BID ADDENDUM NO. 8

October 22, 2018

Johnson Student Center
Building Demolition, Increment 1 (Demolition) and Increment 2

RANCHO SANTIAGO COMMUNITY COLLEGE DISTRICT
SANTA ANA, CA

SHEET NUMBER
P3.03

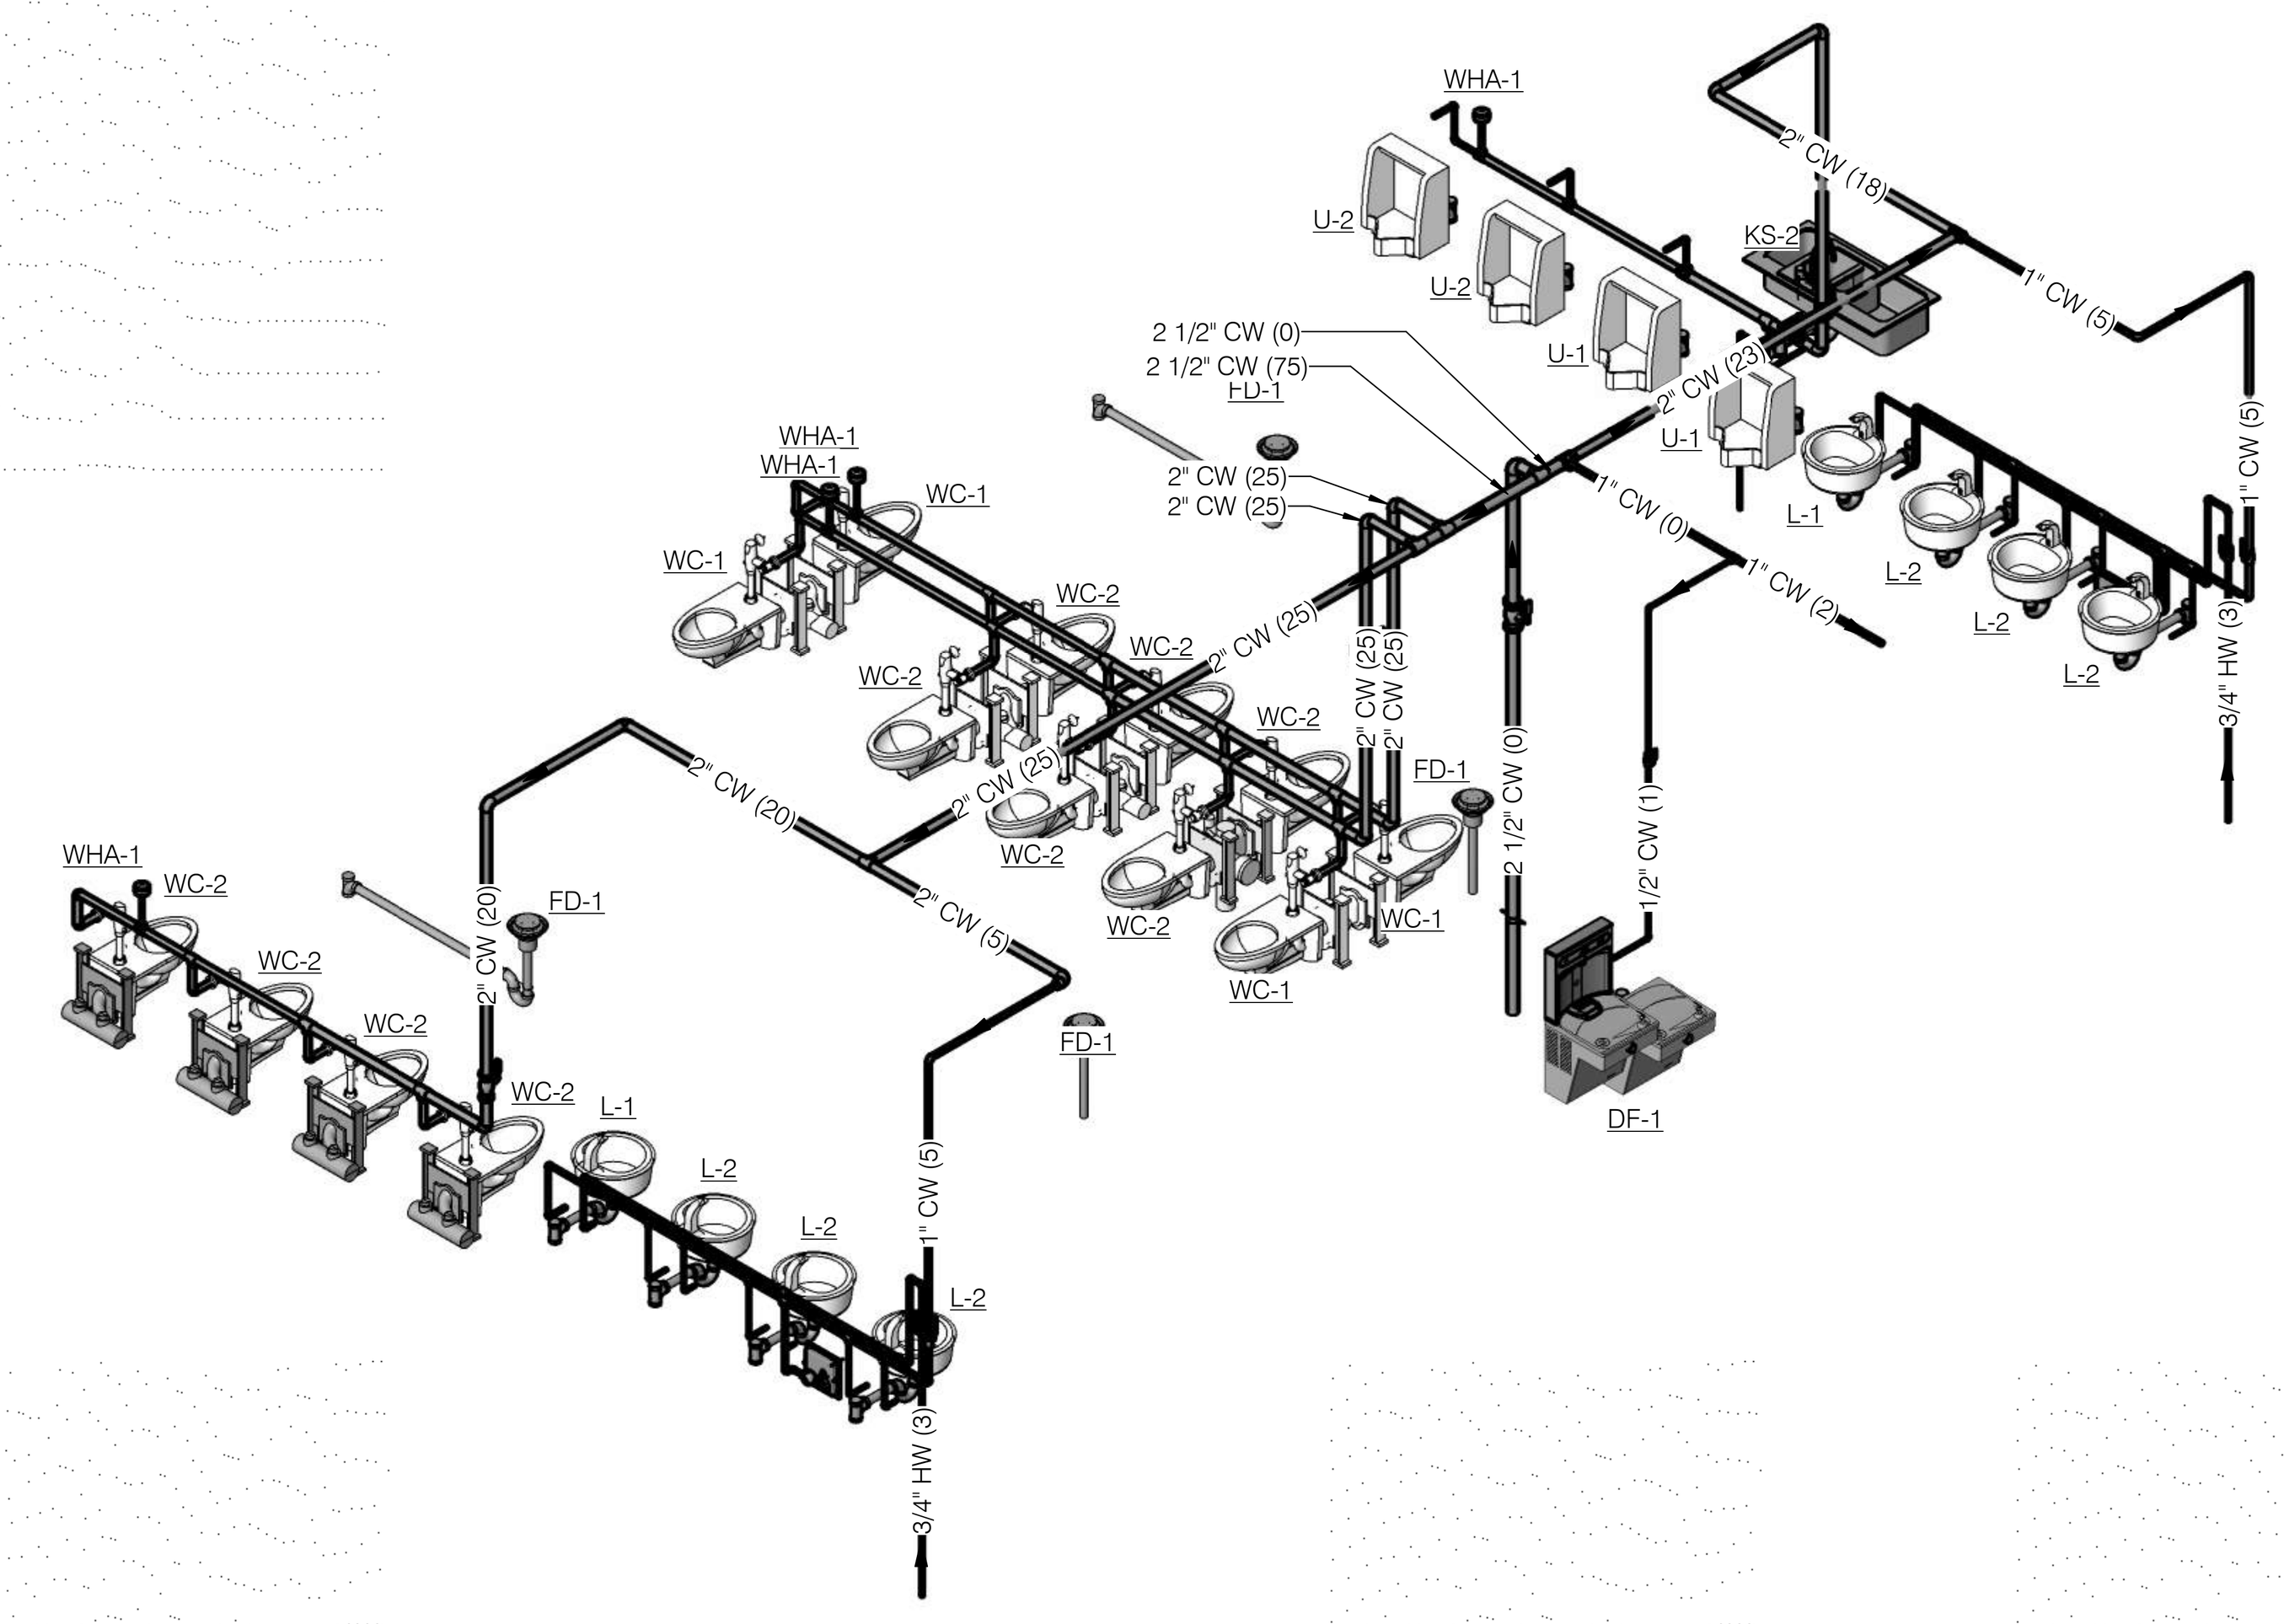
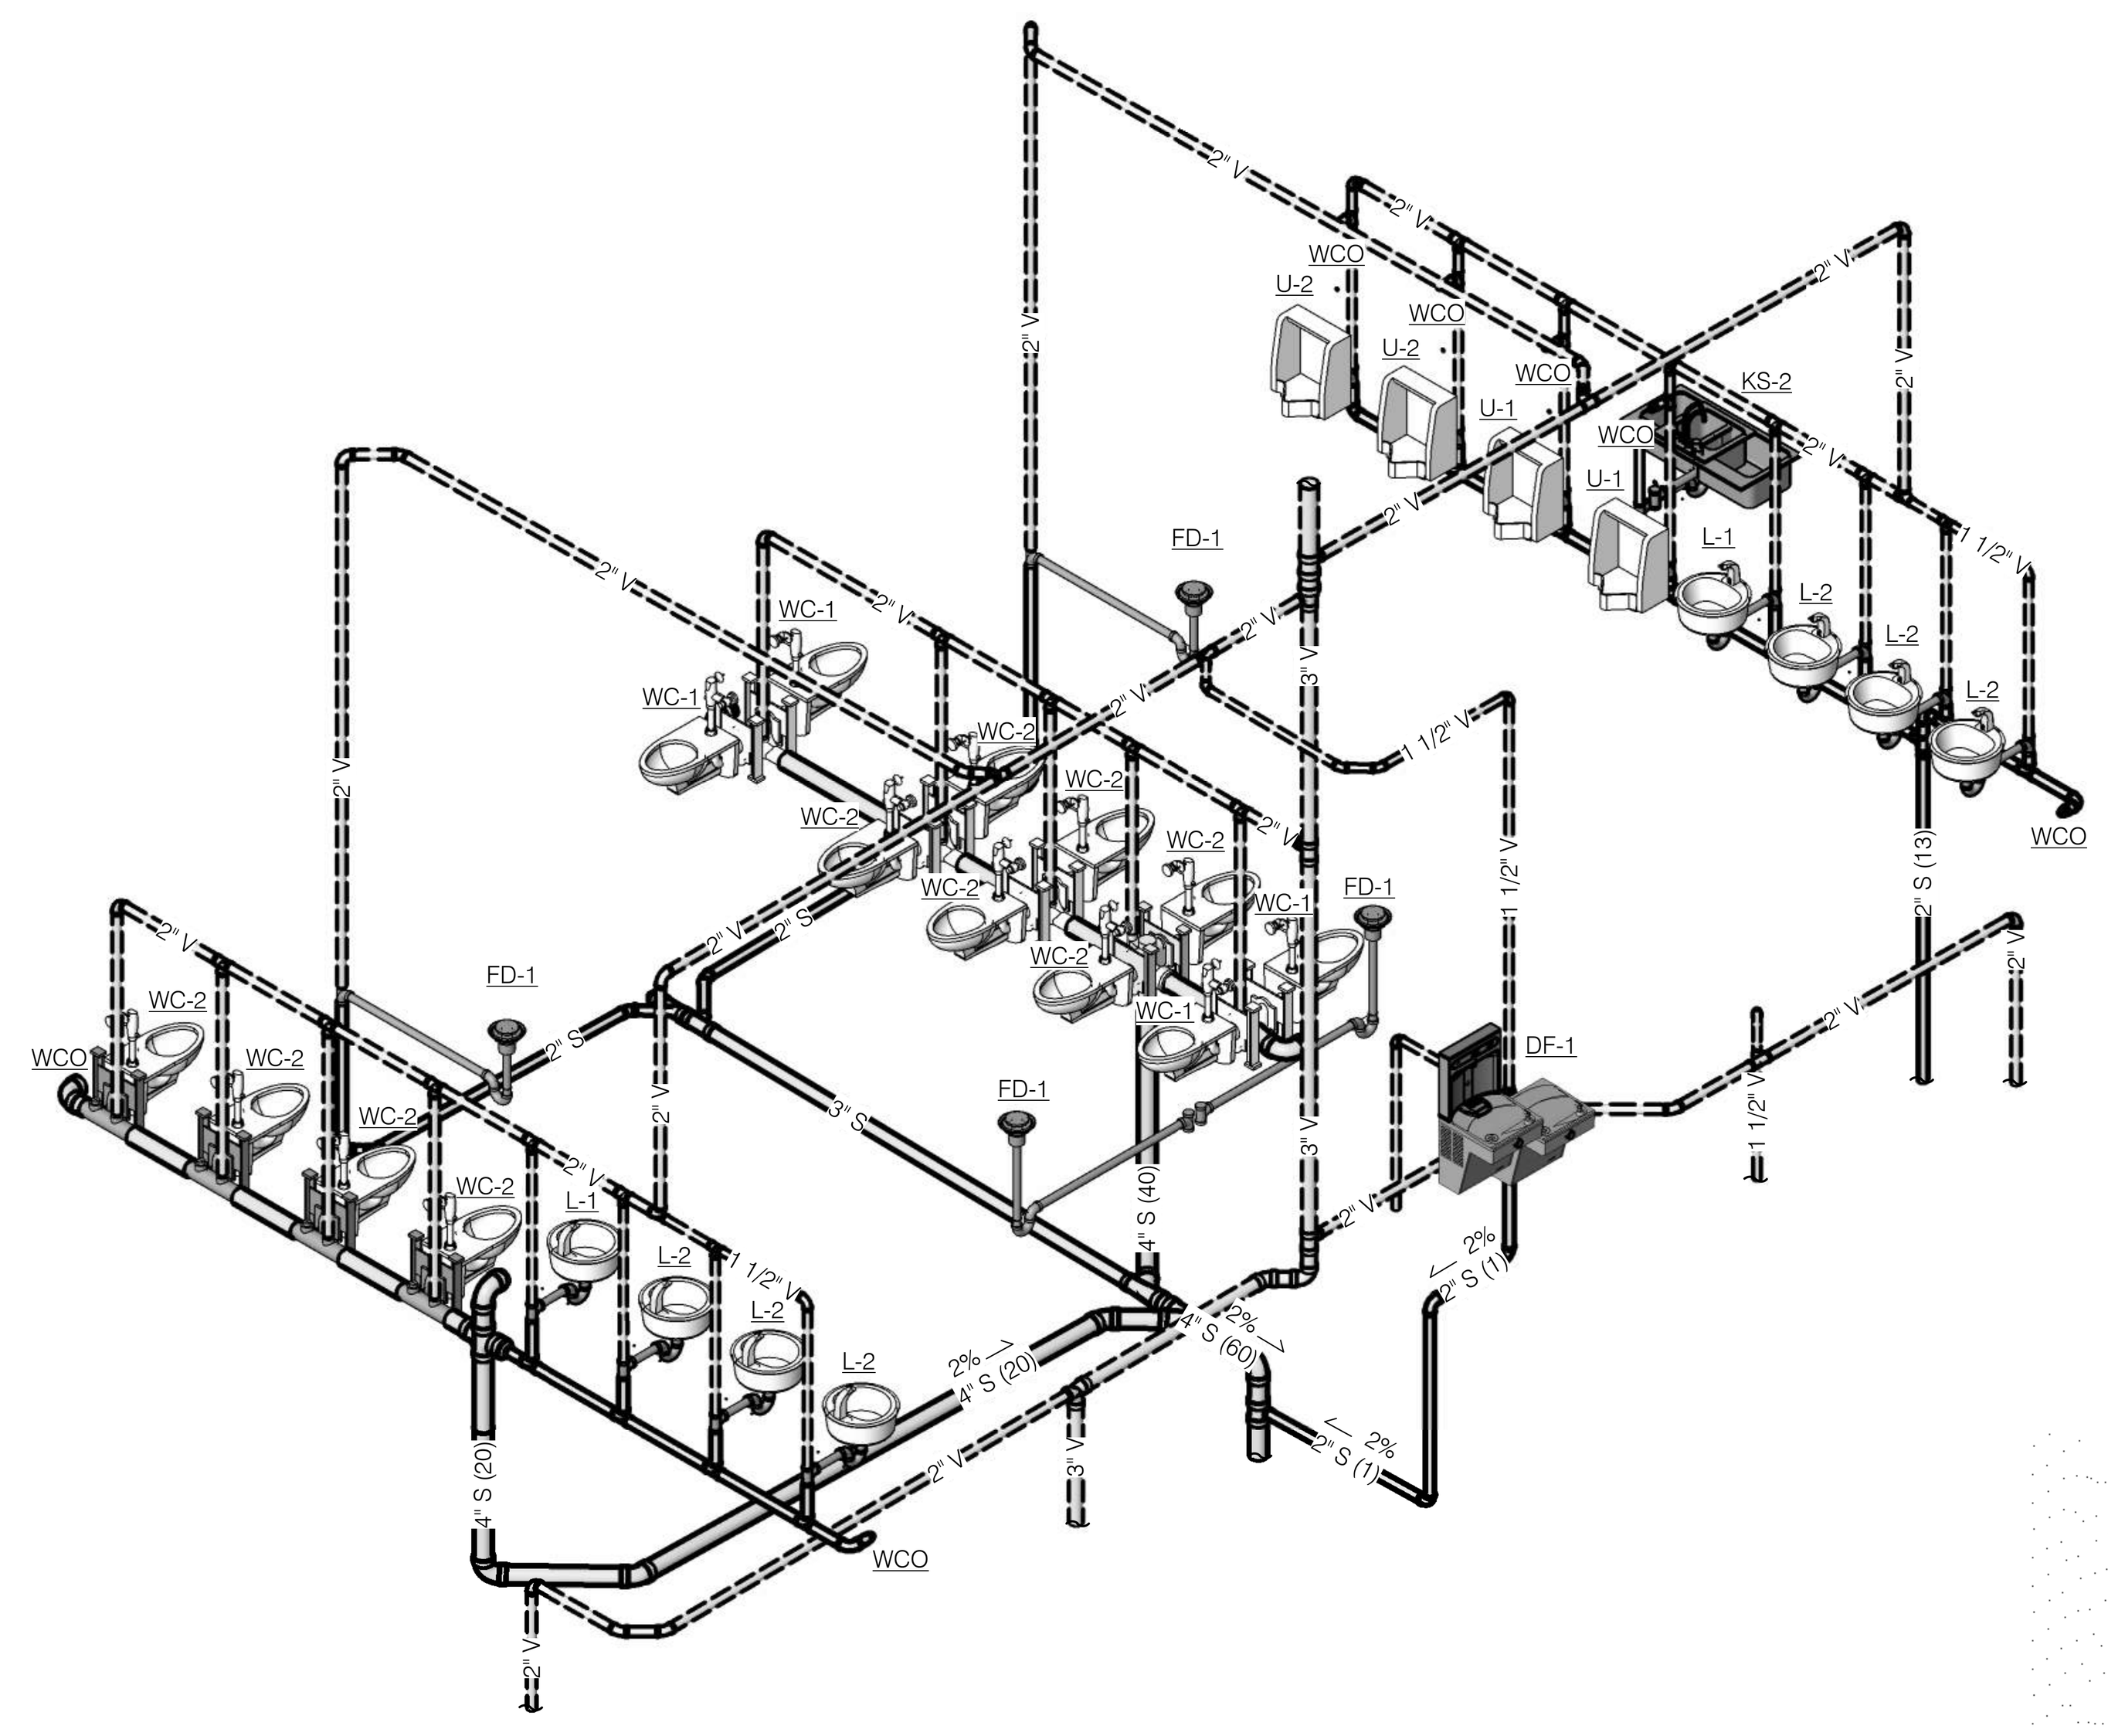
Plumbing/Electrical:
  - Increment 2: Revised single sinks to double sinks with garbage disposals. Refer to attached cutsheets KS-1, KS-2 and revised sheets P0.02, P2.12, P2.22, P3.03, E0.03, E0.11, E2.21.
